**Supplemental Erosion Monitoring Plan
for
Box Canyon Hydroelectric Project
FERC No. 2042**

**Submitted by
Public Utility District No. 1 of Pend Oreille County
Newport, Washington**

**Box Canyon Hydroelectric Project
FERC No. 2042
Supplemental Erosion Monitoring Plan**

Box Canyon Shoreline Erosion Monitoring Plan Peer Review Response Summary

Figure 1. Erosion zones along a longitudinal profile at Box Canyon Hydroelectric Project.

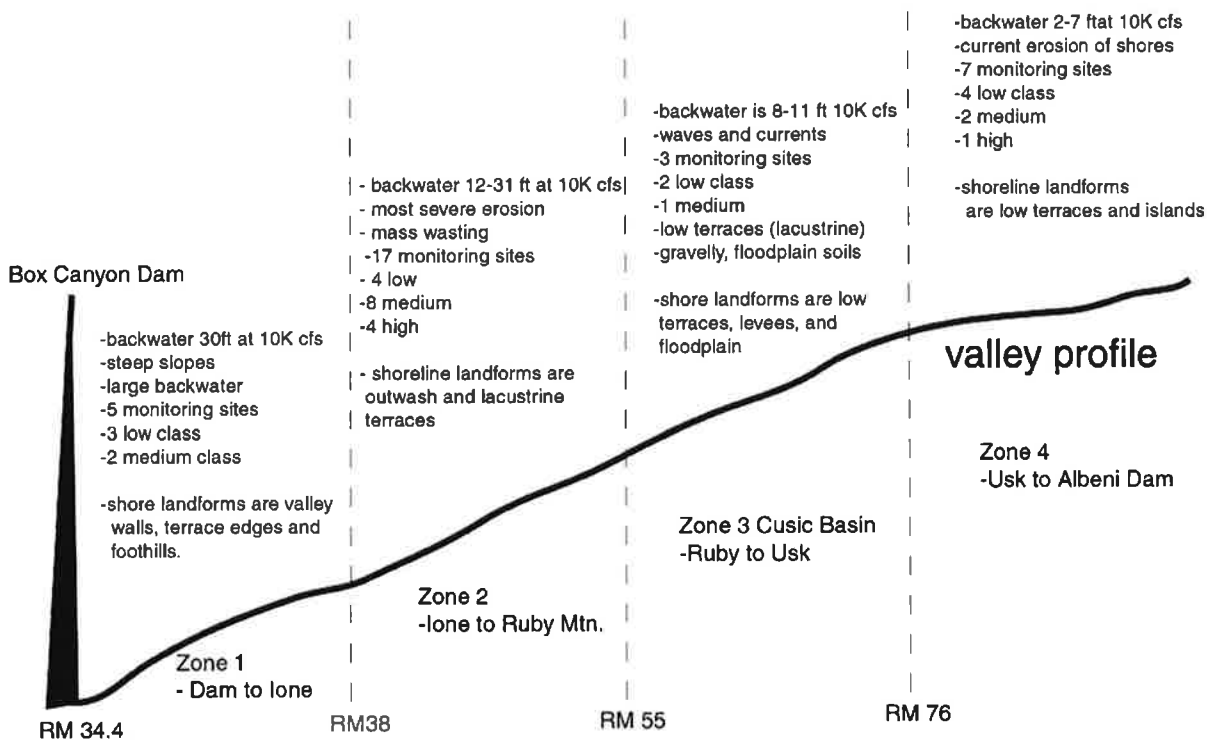
It is unclear to me whether or not the location of the sites is sufficiently stratified to account for variations in shoreline geology (Figure 1). Based on the field site review, the selection of sites seems adequate, but there remains a need to map the geology of the entire shoreline along the project to address this issue and several others. This mapping will allow for more accurate extrapolation of recession rates from monitored to non-monitored sites.

7) Include figures in the Plan that explain some of the geometric relationships between the project, the river and the monitoring plan. Comprehending the complicated spatial distribution of erosion both along transects and longitudinally within the project was difficult. I developed two figures to help people not so familiar with the erosion monitoring plan understand processes. Figure 1 shows how the project affects water levels and erosion in four zones along the project from Newport to Albeni Dam. Figure 2 shows various geometric components of reservoir shoreline erosion. It would also be helpful to include examples of transect data and a summary table of erosion for the entire period of monitoring.

R32. We agree that some diagrams or figures can be useful. Diagrams like reviewer's Figure 1 can be included within monitoring reports once the landform and stratigraphy mapping are complete.

Figure 2. Reservoir shoreline erosion geometric concepts, modified from Lawson, 1986. Note (a) is bluff (bank) recession and (b) vertical erosion, and (c) temporary deposition.

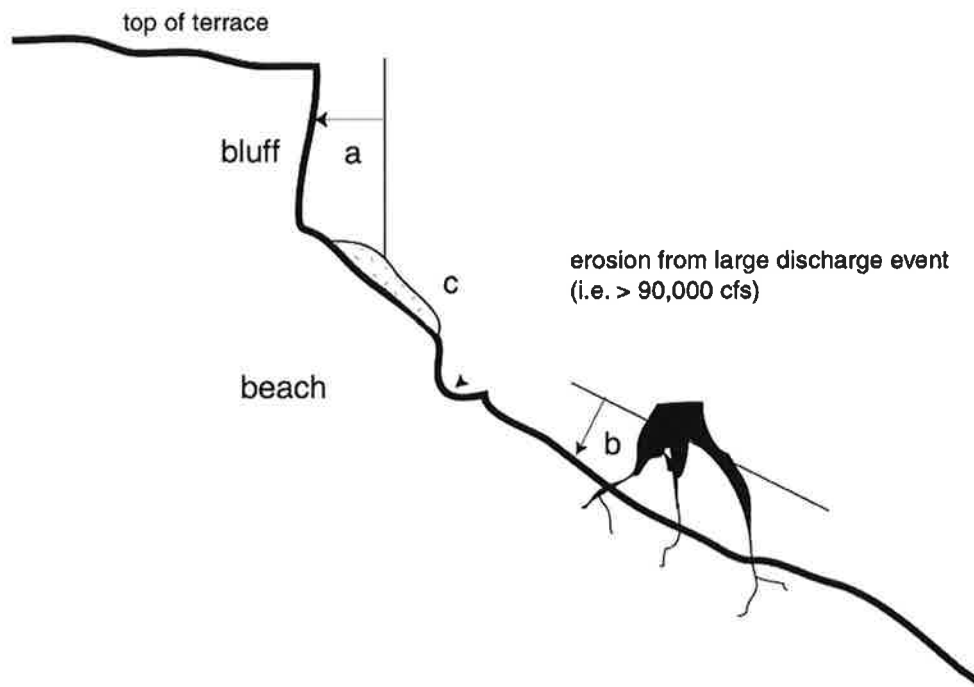
- The plan emphasizes the vertical component of erosion along a profile, but not horizontal bank recession (Figure 2). These terms are not interchangeable, and in fact have very different meanings in the reservoir erosion literature (Lawson, 1985, Figure 6; Gatto and Doe, 1983). Lawson defines erosion as a 'mass concept' while noting that bank recession is a 'geometric concept'. Horizontal retreat of the bluff face is probably more relevant to ultimate development of an erosion control plan, and is the dimension of reservoir shoreline erosion most often monitored and discussed in the literature. Measurement of horizontal bank recession also is the net result of several erosion processes, regardless of elevation on profile (or transect). Reporting bank recession as the average of both positive and negative vertical changes obscures the importance of significant changes at any location along a given transect. It also minimizes the apparent rate of bank recession. For example, the 2006 monitoring report Attachment A lists site 28 as undergoing a 'slow' rate of bank erosion, yet the transect 1 clearly shows ~5 ft. of bank recession between 2000 and 2005.

If the focus of the plan were shifted from vertical, along profile measurements of change, to horizontal bank recession (Figure 2), then less expensive monitoring techniques could be used at many of the 47 sites. These methods might include bank pins and measurement of retreat of the bluff face from a series of stakes placed well back of the eroding face.

1) Clarify what is being measured in the plan and consider emphasizing bank recession instead of vertical changes on a transect (Figure 2). Understanding the net result of several processes and rate of bank recession will provide better guidance for prioritizing sites in an erosion control plan. If this approach is adopted, bank recession is less expensive to monitor than vertical erosion at 47 sites and more than 140 transects.
